**From:** Carl J. Michelsen [CMichelsen@pesenv.com]  
**Sent:** Tuesday, October 18, 2016 4:28 PM  
**To:** Roe, Dilan, Env. Health; Detterman, Mark, Env. Health  
**Cc:** 'Cunningham, Denise'; 'Tom Graf'; Scott Morrison  
**Subject:** RE: Response to Conference Call Comments  
**Attachments:** 22000302005\_PSG\_1-2-2.pdf

Dilan and Mark – In our conference call on September 21<sup>st</sup>, you raised a number of issues that required resolution before granting approval of construction of the townhomes on the State Street side of the project.

**PCE Concentrations in Shallow Soil Vapor and Proposed Sample Locations**  
 State Street Center  
 Fremont, California

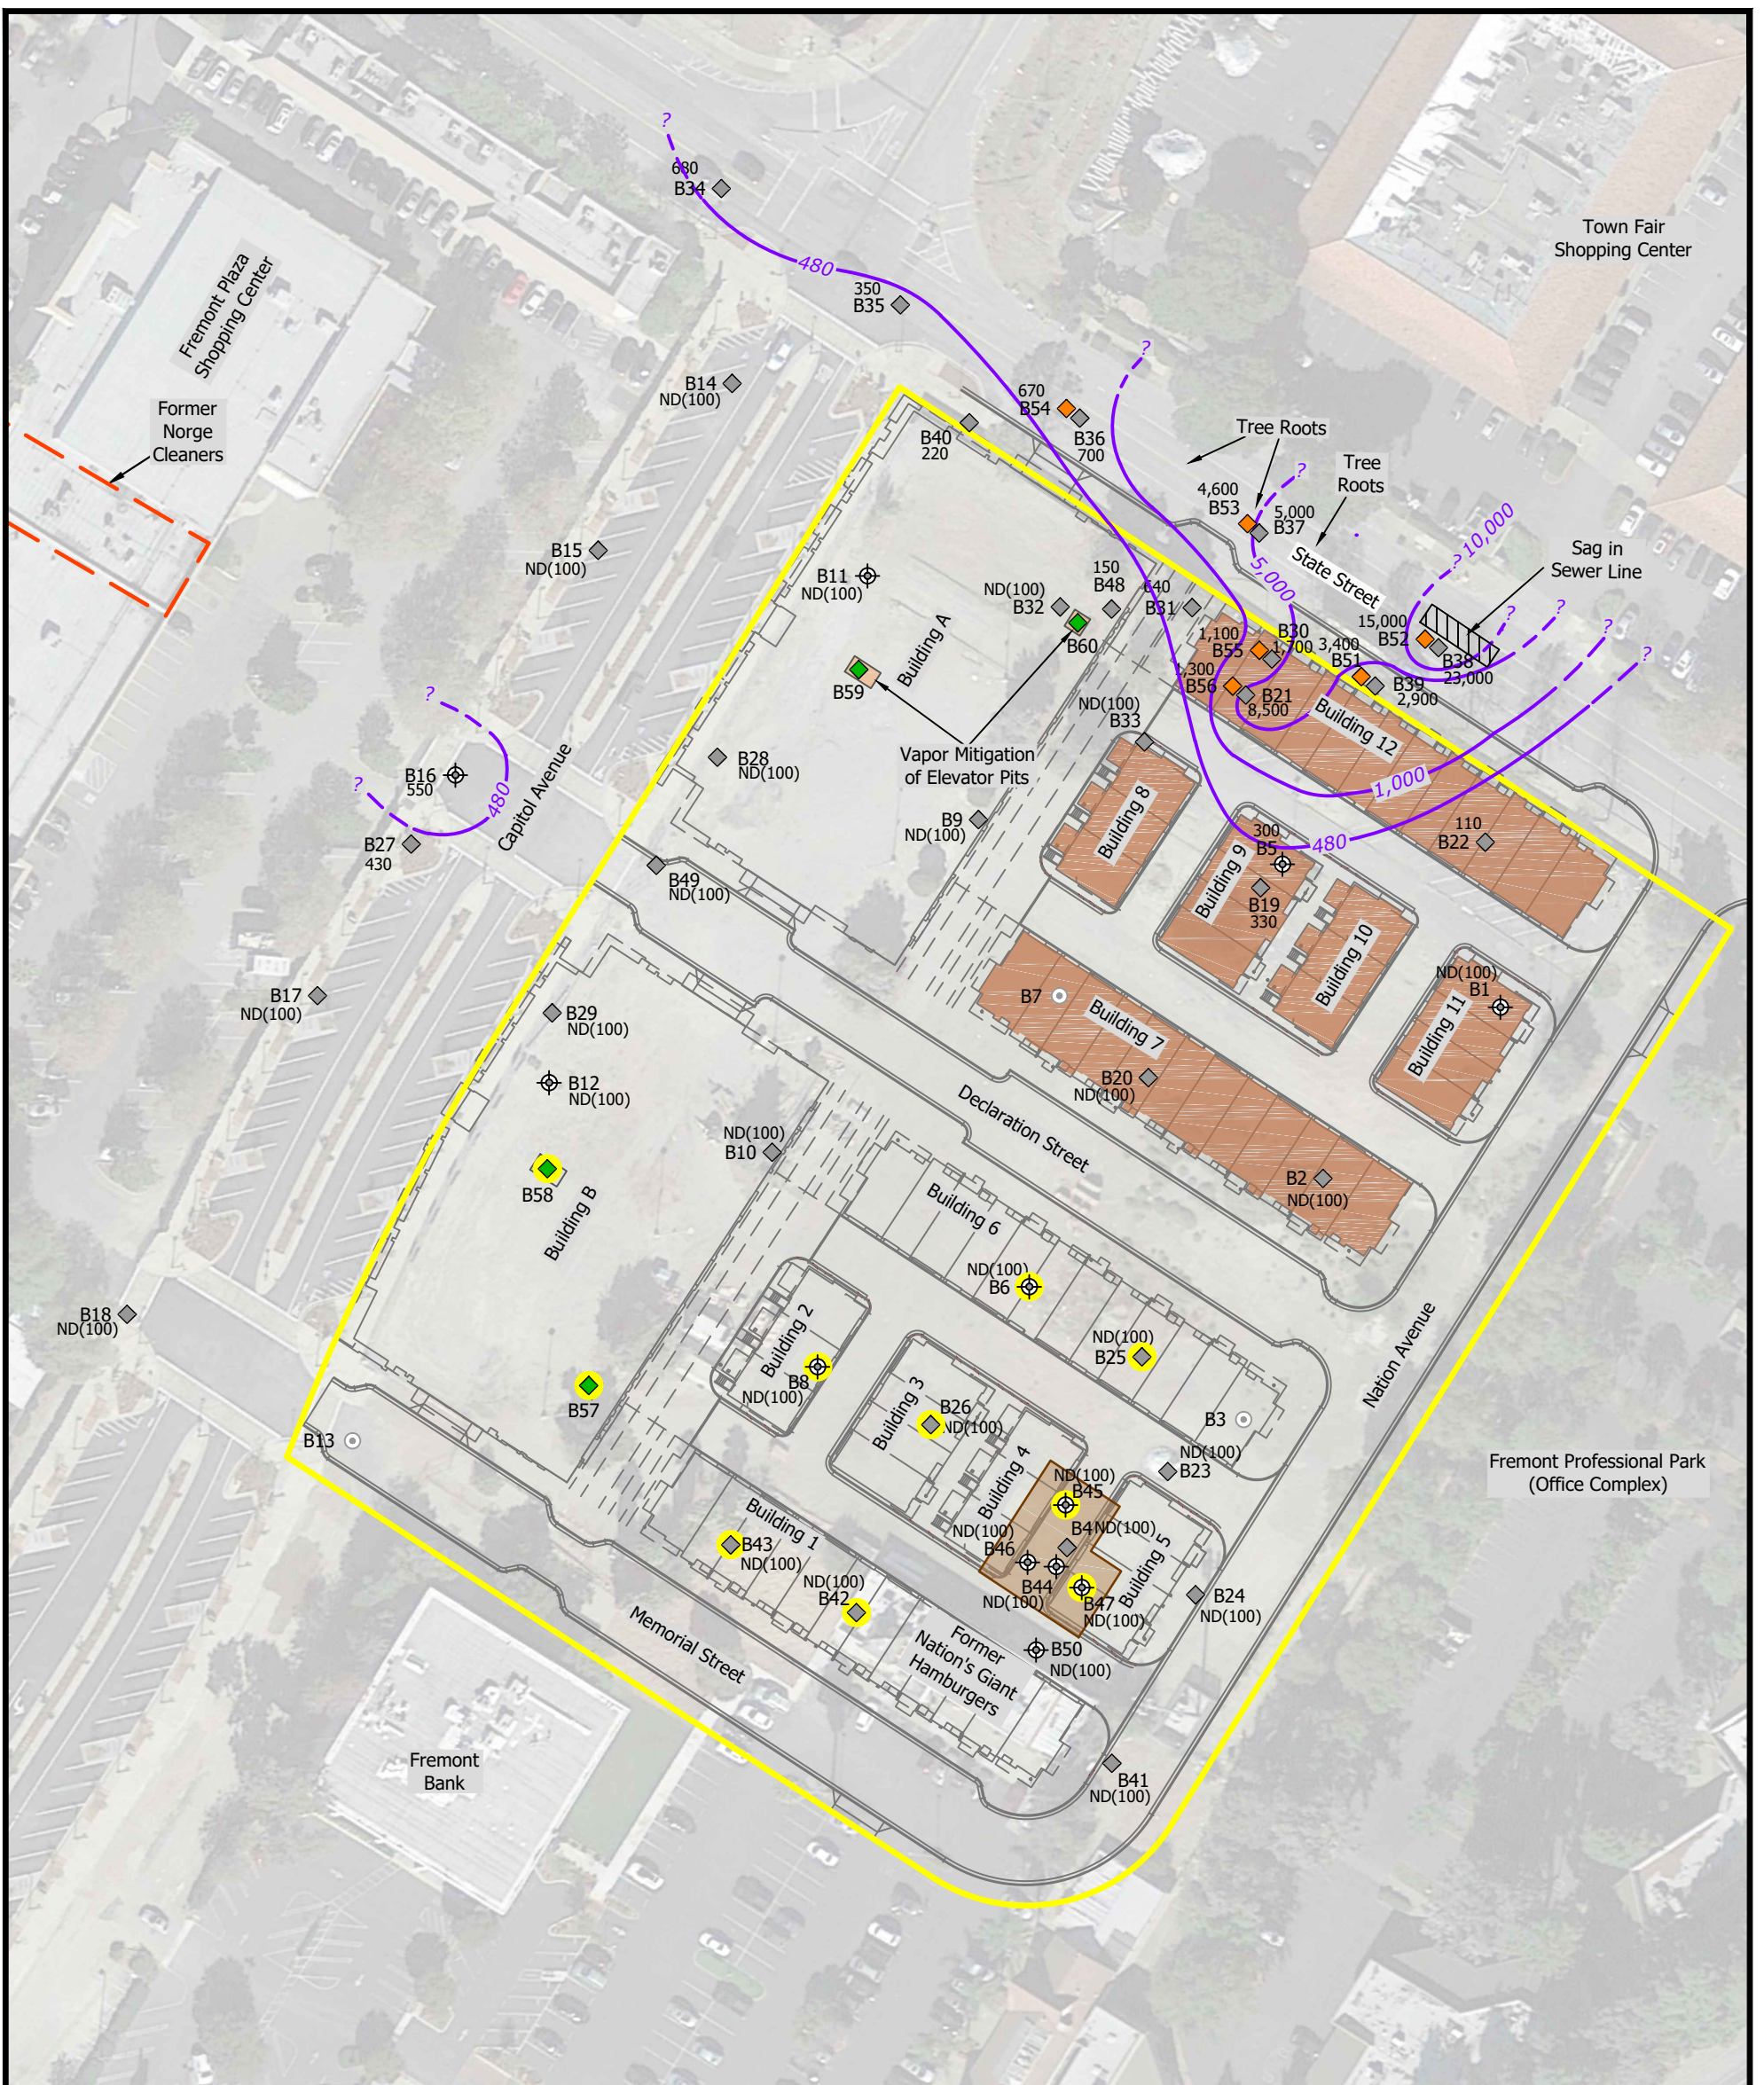
Dilan & Mark – the rough sketch that I sent you earlier was not very readable. Attached is a better version that shows the proposed re-sample locations more clearly (see yellow highlighted locations). Let me know if this (and the general text sampling approach described below) looks acceptable. If so, I will submit the workplan describing the proposed sampling to you as soon as possible.

- 3) The RWQCB is preparing a letter documenting the use of loamy sand and their determination regarding the benzene concentrations above ESLs.
- 4) For the requested soil vapor sampling for vinyl chloride, I propose that we collect soil gas samples from Buildings 1- 6 (i.e., the townhomes without vapor mitigation). For Building B, the podium building on the south side of the site, two soil gas samples would be collected at the two elevator shaft locations. For Buildings 1 and 6 (the long buildings that run NW/SE), two soil gas samples would be collected from each building and collected at the same location as prior sample locations B42/B43 (Building 1) and B6/B25 (Building 6). For the remaining townhomes, soil gas samples would be collected at prior sample locations B8 (Building 2); B26 (Building 4); B45 (Building 4); and B47 (Building 5). All of the soil gas samples collected from the townhome locations would be collected at 5 ft below current grade. See attached rough sketch map for proposed locations. For the two elevator shaft samples, soil gas samples would be collected immediately below the base of the future elevator shaft. All ten soil gas samples would be collected via the Summa canister method and analyzed by a fixed laboratory (K-Prime) to achieve the low-level VC detection limit. Note that for the townhome samples, the current grade largely reflects the future pad elevation and that in some locations the cement treated base (CTB) material may be encountered at less than 5 ft. below grade. In cases where the CTB is encountered, the soil gas sample will be collected from the soils above the CTB at the deepest depth
